DEVELOPMENT APPLICATION ASSESSMENT REPORT

Application Number:	DA2022/1034
----------------------------	-------------

Responsible Officer:	Luke Zajac
Land to be developed (Address):	Lot 2 SP 60808, 2 / 20 Clifford Avenue FAIRLIGHT NSW 2094
Proposed Development:	Alterations and additions to a dwelling within an attached dual occupancy
Zoning:	Manly LEP2013 - Land zoned R1 General Residential
Development Permissible:	Yes
Existing Use Rights:	No
Consent Authority:	Northern Beaches Council
Land and Environment Court Action:	No
Owner:	William Hope
Applicant:	William Hope

Image 1: Maximum height of building breach

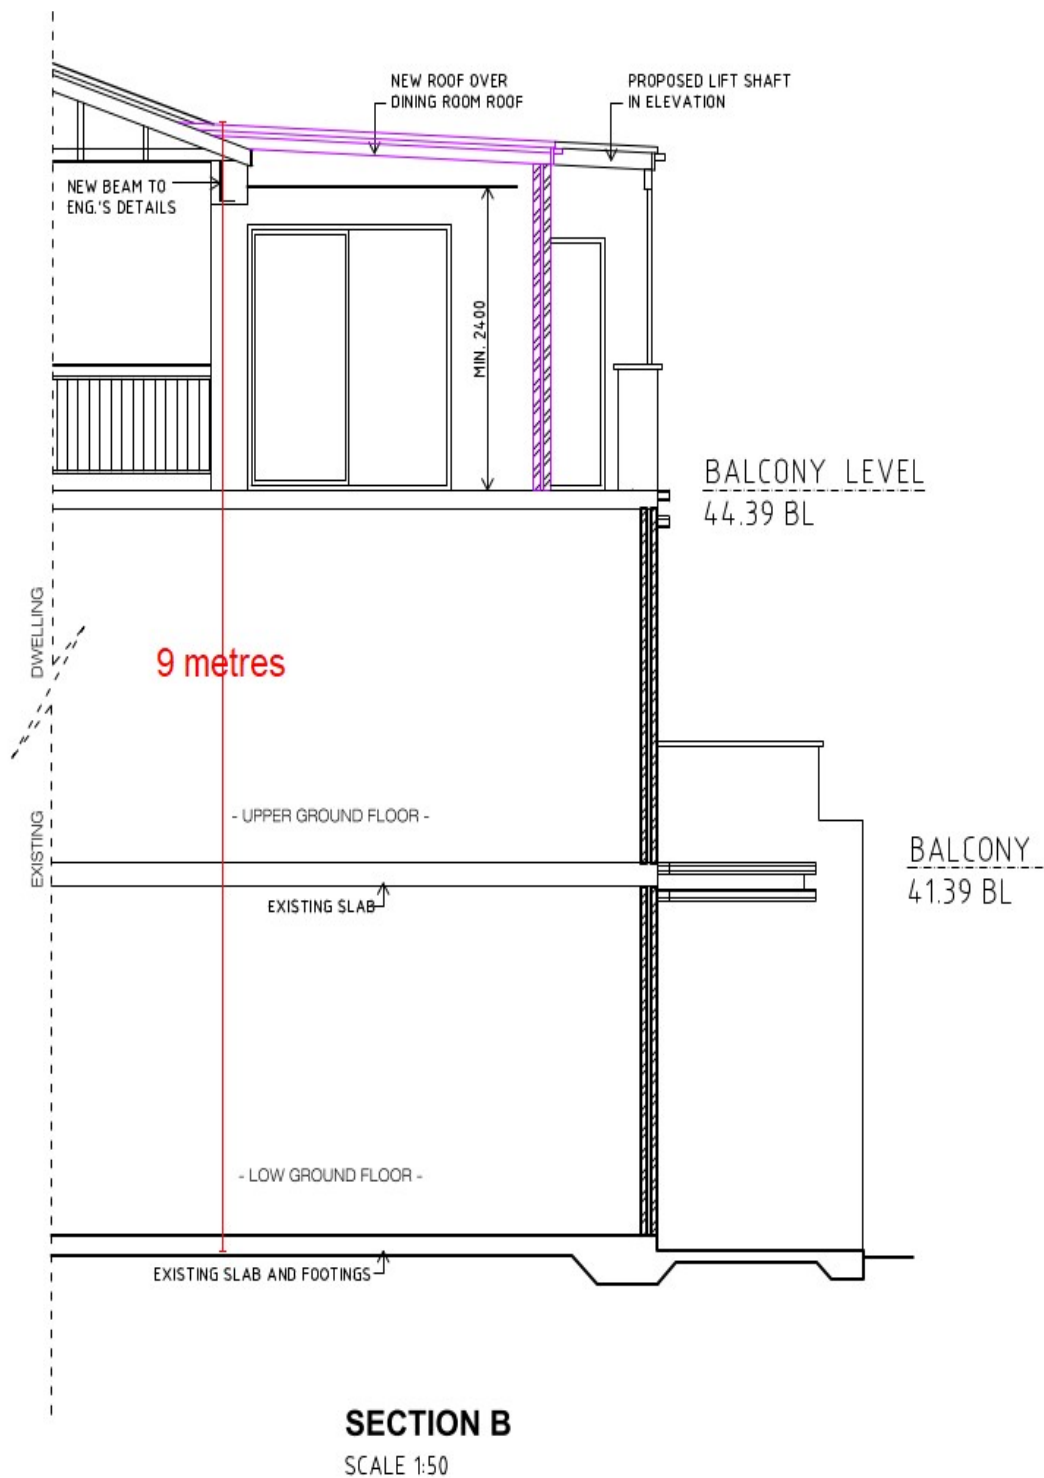
Development standard:	Height of buildings
Requirement:	8.5m
Proposed:	9m
Percentage variation to requirement:	5.8%

The exceedance is the eastern and southern elevation building element and relates to the topmost floor plate with the upper wall and lean to roof section where there is an exceedance by 500mm due to the site's topography and in particular the terracing and benching along the eastern side boundary that created the floor plates across the site.

It is considered that the Applicant's reasoning to vary Clause 4.3 Height of Building of the Manly Local Environmental Plan (MLEP) 2013 as being acceptable as the portion of the built form that extends beyond the prescribed maximum building height is limited to front living room and roof addition, that results from the existing benching of the site to negotiate its steep slope. Strict compliance with this control is unlikely to give rise to adverse amenity impacts (such as privacy, solar access or views) to adjoining and nearby properties. The extension will be lower than the existing roof ridge height and has been designed to integrate with the existing architecture of the dwelling, maintaining the existing side setback and stepped front setback for the upper addition. This assists when applying flexibility for the building height standard as it mitigates an obtrusive built form when viewed from the Clifford Avenue, ultimately resulting in a dwelling frontage that is commensurate with other large terraced dwellings along Clifford Ave. The maintenance of existing landscaping within the front setback, in conjunction with the front setback distances to the proposed extension, results in a positive visual interest that is anticipated to contribute to the streetscape character.

Council agrees with the applicants argument that the works are consistent with the objectives and strict compliance with the control in these circumstances is considered unnecessary.
